To: Mr. Tim Johnson, American TCB  
From: David Waitt, Airespace  
Subject: Inquiries regarding Certification application for FCC ID QTZVAP1200  
Date: 1 April 2003

These cables connect the main PCB to the external 2.4 GHz antenna connectors

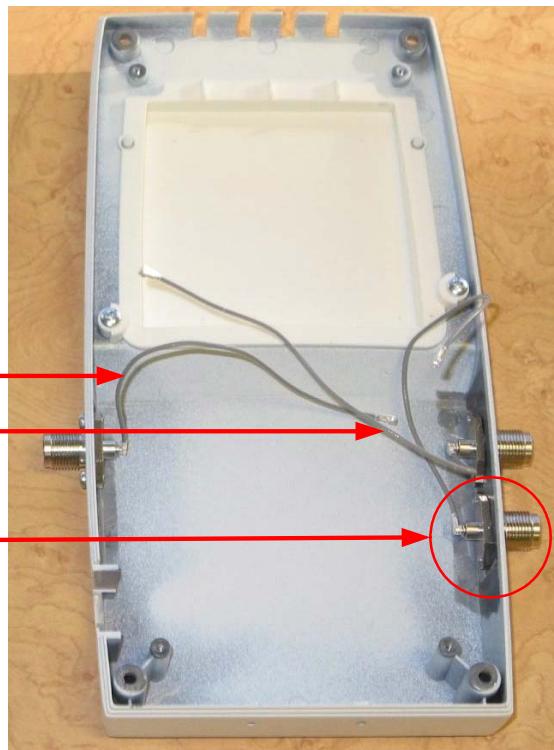
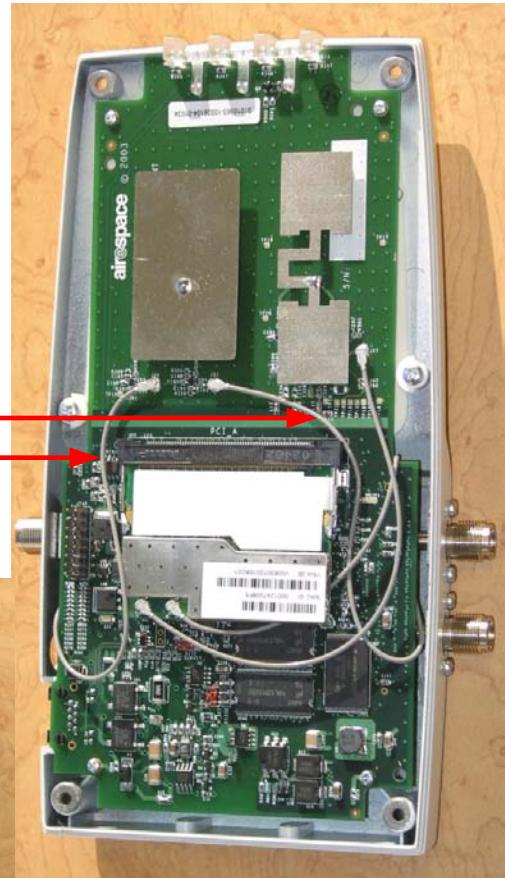
ATCB 4) This submittal appears to contain information regarding external antennas. However, it is not certain how the external antennas connect internally to the original device. Please explain and provide photographs as necessary.

Airespace: The reverse TNC connectors used to support the use of external 2.4GHz antennas are connected to the main circuit board in the radio via short coaxial cables shown in the photos below. Note that the hardware is in place to support external 5 GHz antennas; however the configuration software does not support use of external 5 GHz antennas. Currently, until authorized by the commission, configuring the radio to operate with external 5GHz antennas is not possible.
